UNITED STATES PATENT AND TRADEMARK OFFICE

APPLICATION NO.	FILING DATE	FIRST NAMED INVENTOR	ATTORNEY DOCKET NO.	CONFIRMATION NO.
10/791,101	03/02/2004	Shimshon Gottesfeld	107044-0043	2480
24267	7590	09/27/2007		
CESARI AND MCKENNA, LLP 88 BLACK FALCON AVENUE BOSTON, MA 02210			EXAMINER CANTELMO, GREGG	
			ART UNIT 1745	PAPER NUMBER
			MAIL DATE 09/27/2007	DELIVERY MODE PAPER

Office Action Summary	Application No. 10/791,101	Applicant(s) GOTTESFELD ET AL.	
	Examiner Gregg Cantelmo	Art Unit 1745

DETAILED ACTION

FIG. 4

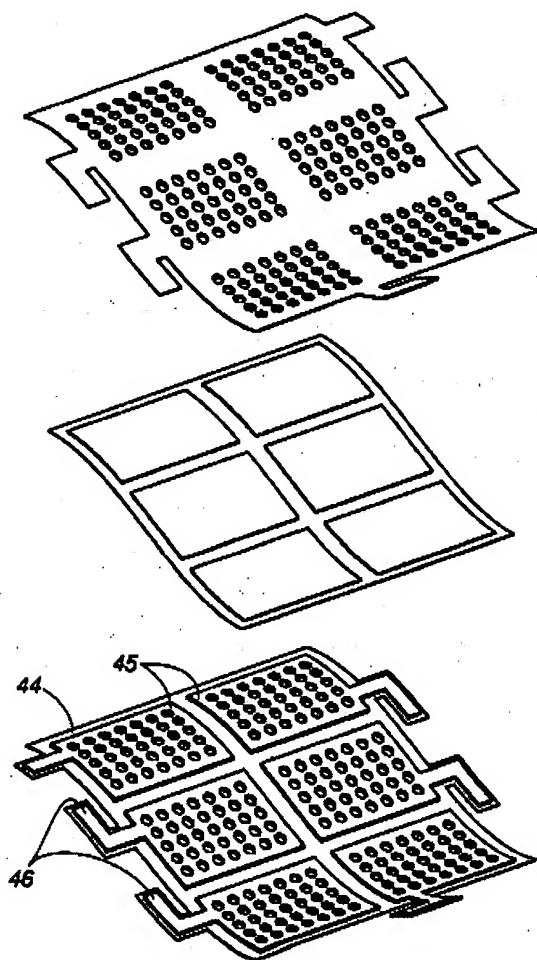
Pratt discloses a conformable fuel cell in Fig. 4, comprising: (A) a membrane electrolyte intimately interfacing with a catalyst layer along each of the membrane's major surfaces being a catalyzed membrane electrolyte, having an anode aspect and a cathode aspect, and which catalyzed membrane electrolyte is flexible (e.g., conformable to a desired shape); (B) diffusion layers sandwiching said catalyzed membrane electrolyte, said diffusion layers being comprised of materials that are conformable; (C) flexible current collectors coupled with each of said anode aspect and said cathode aspect of said membrane electrolyte; (D) fuel delivery means coupled with said anode aspect of said membrane electrolyte that delivers fuel substantially uniformly to said anode aspect while said fuel cell maintains said desired shape (Figs. 2-5); (E) electrical coupling 45 disposed across said anode aspect and said cathode aspect and having means for connection to an application device being powered by said fuel cell (as applied to claim 1).

The current collectors 45 at each of said anode aspect and said cathode aspect apply "adequate compression" effectively over the active area of the membrane electrolyte of each cell (Fig. 4 as applied to claim 2)

The fuel cell in Fig. 4 is shaped to form a curvilinear shape (col. 5, ll. 25-28 as applied to claim 12).

It is evident from at least Fig. 4 of Pratt, that the assembly therein, including a catalyzed membrane electrolyte, is flexible and thus can be "conformed to a desired shape" including a planar shape or non-planar shapes.
